STAFF RECOMMENDATION
4503 Park Avenue
August 16, 2017

Application: Demolition; New construction – addition; Setback determination

District: Park and Elkins Neighborhood Conservation Zoning Overlay

Description of Project: The applicant proposes to demolish a non-contributing outbuilding and to enlarge the principal building with a rear addition. Because the existing house sits less than five feet (5') from the right side property line, a determination on the appropriateness of the setback is required.

Side - East Elevation

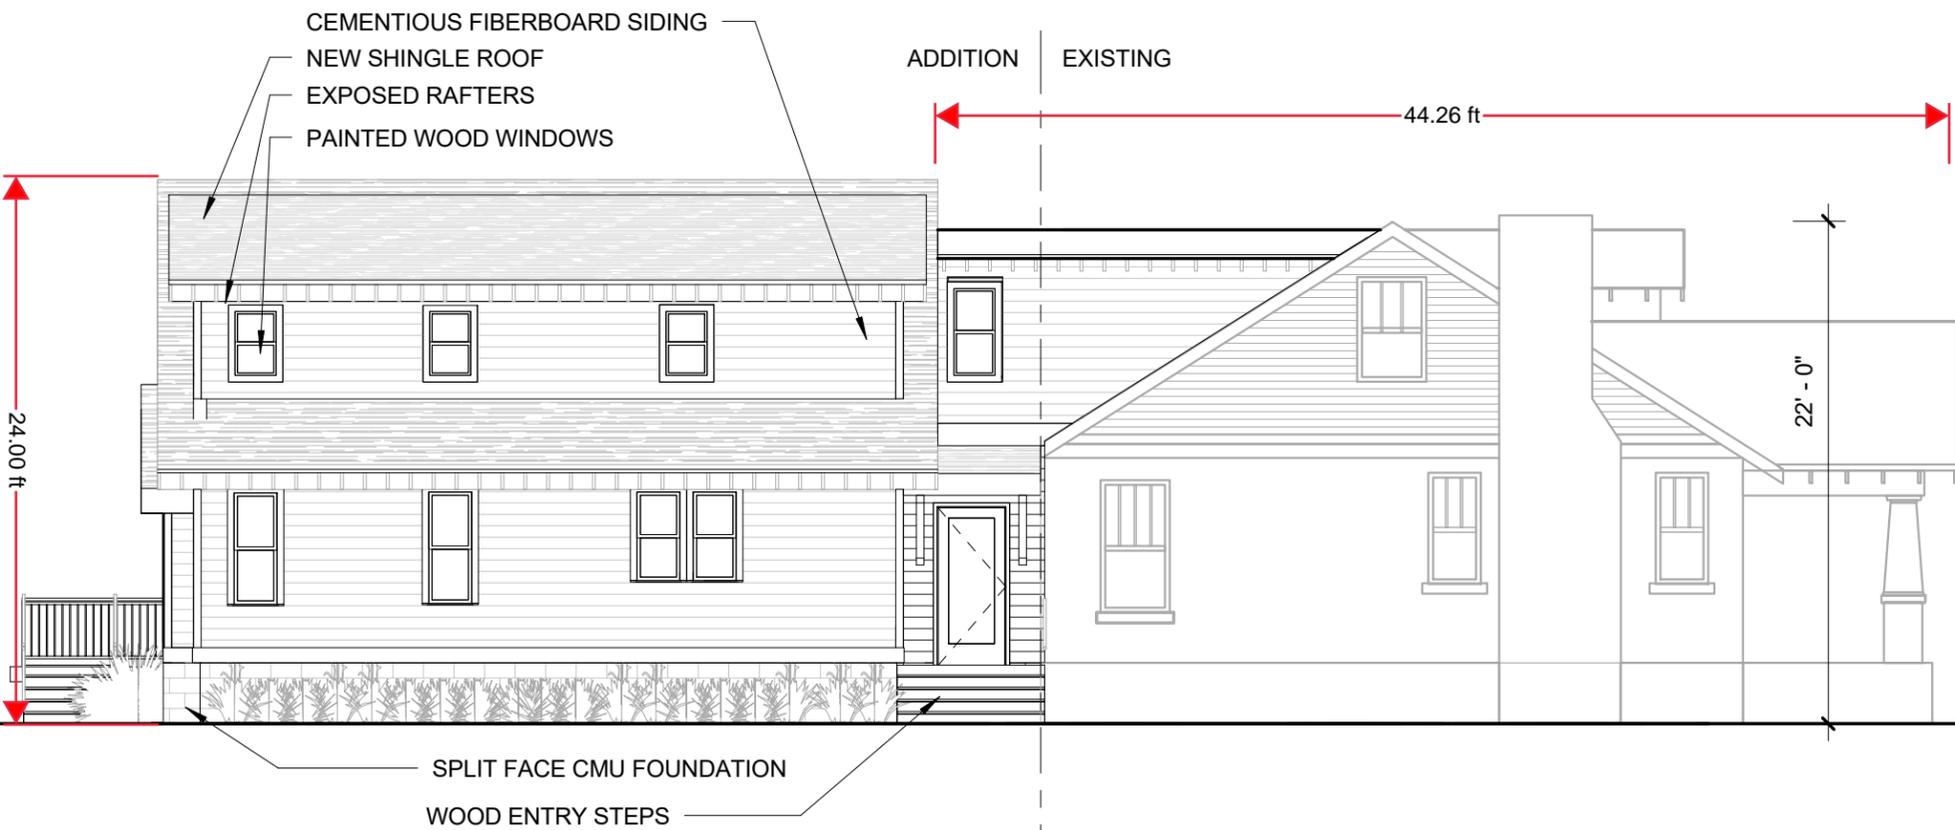
Height & Scale: The new addition will be stepped from the sides of the house by eight feet (8') on the left side and seven feet, nine inches (7'-9") on the right. After extending back six feet (6') the addition will step back out six feet, six inches (6'6") on the left and on the right to align with the right wall of the house. The primary mass of the addition will extend another thirty-two feet (32') toward the rear, giving the addition a total depth of thirty-eight feet (38'), one foot less than the depth of the original house. The primary mass of the addition will be one and one-half stories with a ridge height at twenty-four feet (24') tall, or two feet (2') taller than the existing ridge but with eaves matching the height of the existing eaves.

Although the addition is taller than the historic house, the additional height is minimal and begins more than forty feet (40') back from the front of the house, well behind the original mass and differentiated from it by a narrow hyphen connection. Additionally, while the depth of the addition matches that of the original house the overall massing is subordinate because the addition is narrower. Staff recommends that, if approved, the front of the taller gable shall be clipped to further reduce the perceived height.

Roof form: The historic house has a side-gabled roof form with a 7:12 pitch. The rear-oriented gable roof of the addition will have a slightly steeper roof at 8:12 pitch. This is a minimal difference that will not be perceptible from the right-of-way. Each side of the addition will have a shed-roofed dormer with a 3:12 pitch. These roofs are compatible with the roofs of surrounding historic buildings. Staff finds that the proposed roof forms are compatible with the historic house's roof and meet Sections II.B.1.e and II.B.2 of the design guidelines.

1. The front of the taller gable of the addition shall be clipped to reduce the perceived height; and
2. Staff shall approve the final selections of windows, doors, and roofing prior to purchase and installation.
